# PARK CENTER SUBDIVISION 1200 W. COLONIAL

## SUMMARY

## Minor Subdivision Plat

# PROPOSED PLAT

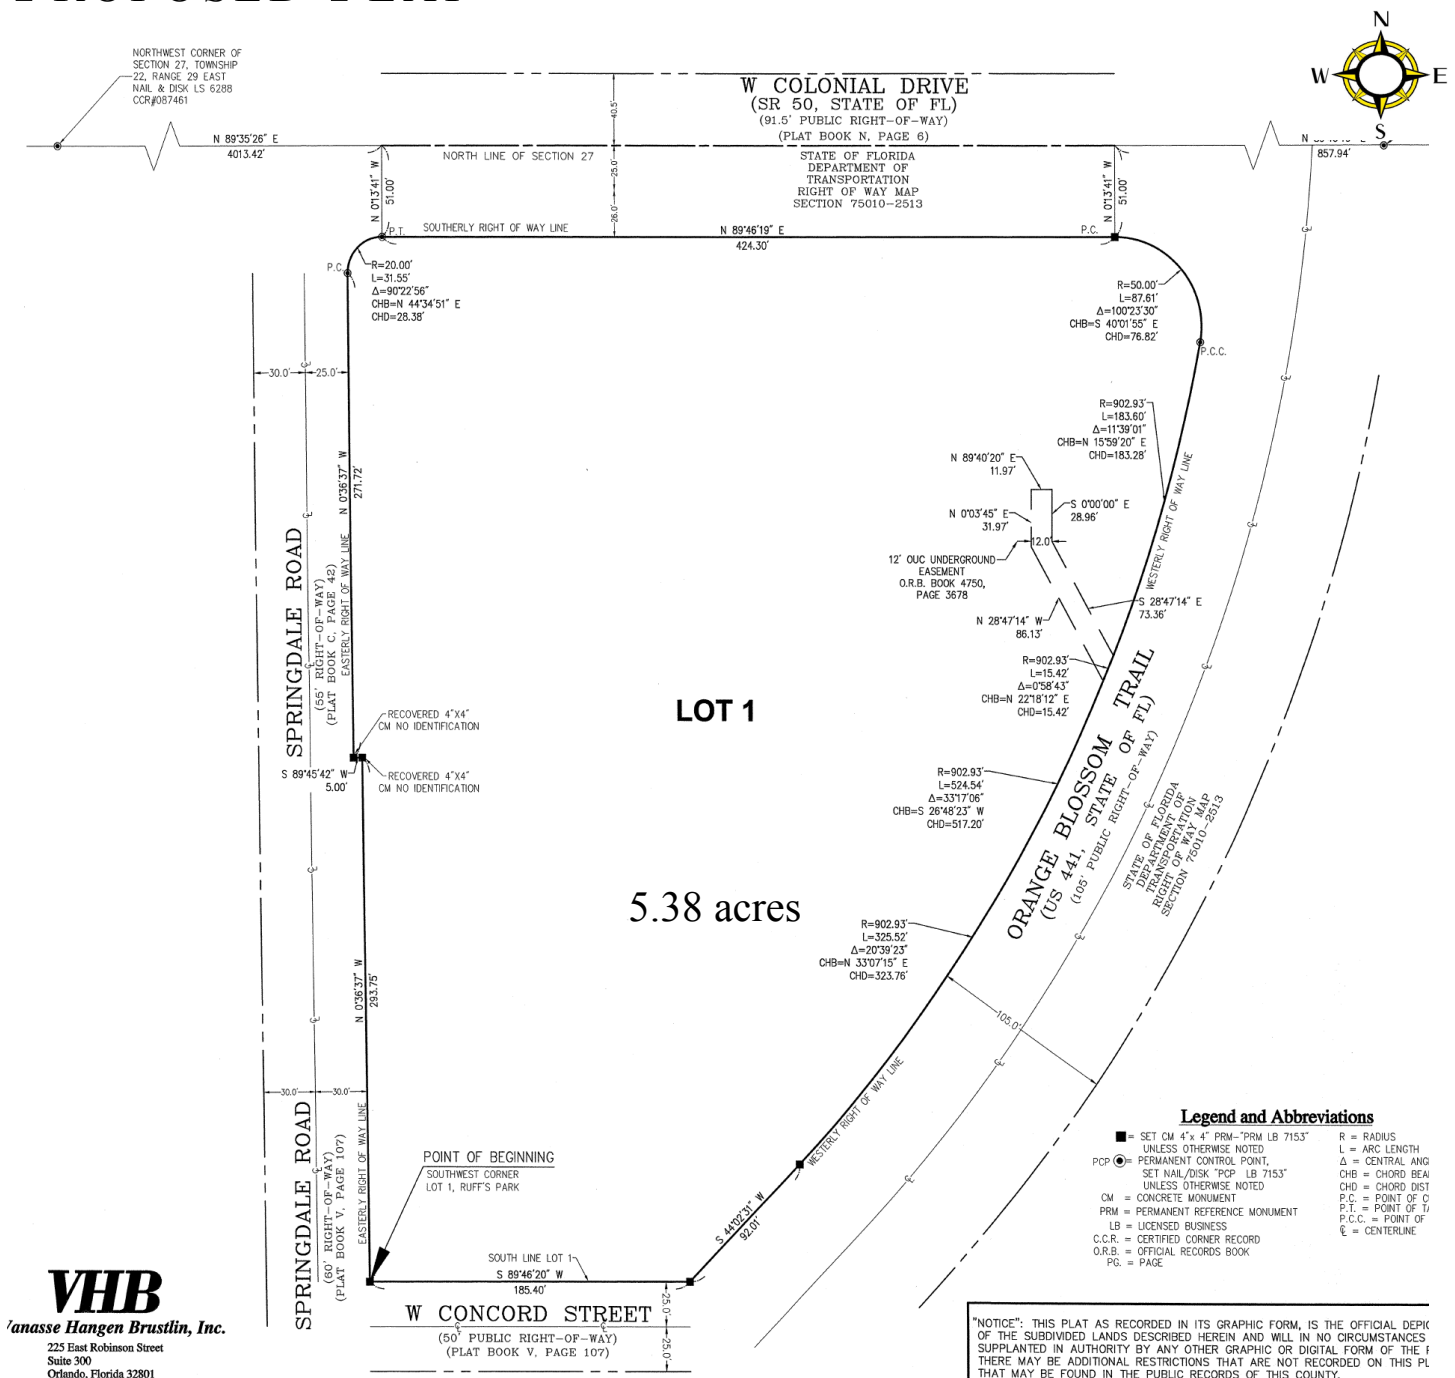
8. Plat Face Changes - There are a number of changes required to the face of the plat. In addition to the changes required on the plat, the following is a list of additional requirements. 1) Changes to the face of the plat. (A copy has already been returned to the surveyor). 2) Recording Fees (Checks should be made payable Orange County Comptroller.) 3) The plat must be reviewed by Orange County prior to recording. Begin this process by taking a copy of the executed plat to Room 1700 (Orange County Property Appraiser's Office, Attn. Rocco Campanale), 200 S. Orange Avenue, Sun Trust Bank Center. The original completed Statement of Lien from Orange County is required by this office. The Statement of Lien must be received by this office prior to recording the plat.

1. The title opinion indicates two separate owners of records: Park Center Properties, I, a Florida general partnership and Park Center Properties, II, a New York partnership. Both must execute the dedication.
2. The notary block(s) must be corrected to properly reflect the ownership tier(s) of each owner and must include the statute required "how known" language. Examples can be provided if necessary.
3. A joinder and consent is required for the mortgage recorded in 5793/2333.
4. The purpose of all areas to be dedicated to the public must be clearly indicated in the dedication, and if nothing is to be dedicated to the public it must be stated as such in the dedication.

Plat Title please correct the following:

1. Change "ORANGE BLOSSOM TRAIL" to "N ORANGE BLOSSOM TRAIL"
2. Please don't spell out North or put a period after the N as this is a directional indicator rather than North as part of the legal street name
